The changes are indicated by a dark vertical line in the margin followed by the amendment number to which the change is applicable. Pages affected by Amendment 8 carry the date in the upper right-hand corner.

SUBJECT/COMMENT	APPLICANT RESPONSE
<u>General</u>	
Applicant should identify whether the application was transmitted to parties, agencies, counties, etc.	See revised Distribution List (pages EFSEC-19a and EFSEC-20).
<u>Transmission Systems</u>	
Discuss impacts of removal of six miles of existing transmission line.	See revised Section 10.9.1.2.
<u>Mitigation</u>	
The Applicant could describe the substance of its mitigation plans more adequately.	The Applicant believes that it has provided a full and adequate description of its mitigation plans. Further details will be provided in the Construction Impact Control Program which will be submitted for EFSEC's review and approval prior to commencement of construction.
Applicant should clarify its use of the terms waste disposal and solid waste disposal.	See revised Section 4.5.4.1.
<u>Geology/Groundwater</u>	
Reference PSAR Amendment 26 on geology.	ASC/ER Section 2.5 already references PSAR Section 2.5 on geology and includes by thi

FIGURE 2.2-22a

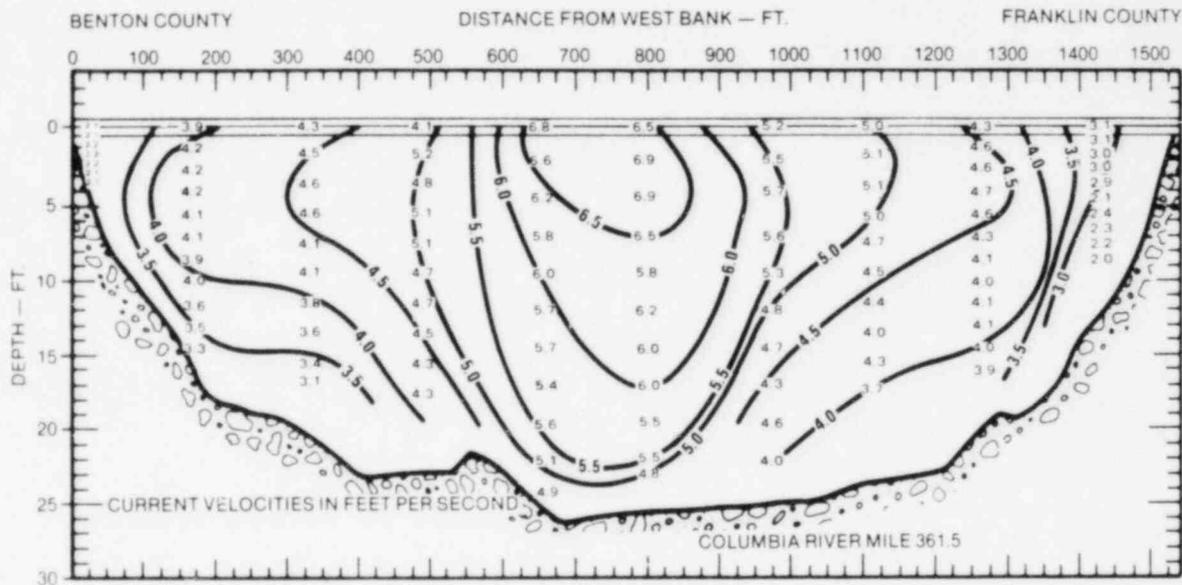
Dimensions should be given on the vertical axis on Figure 2.2-22(a).

See revised Figure 2.2-22(a).
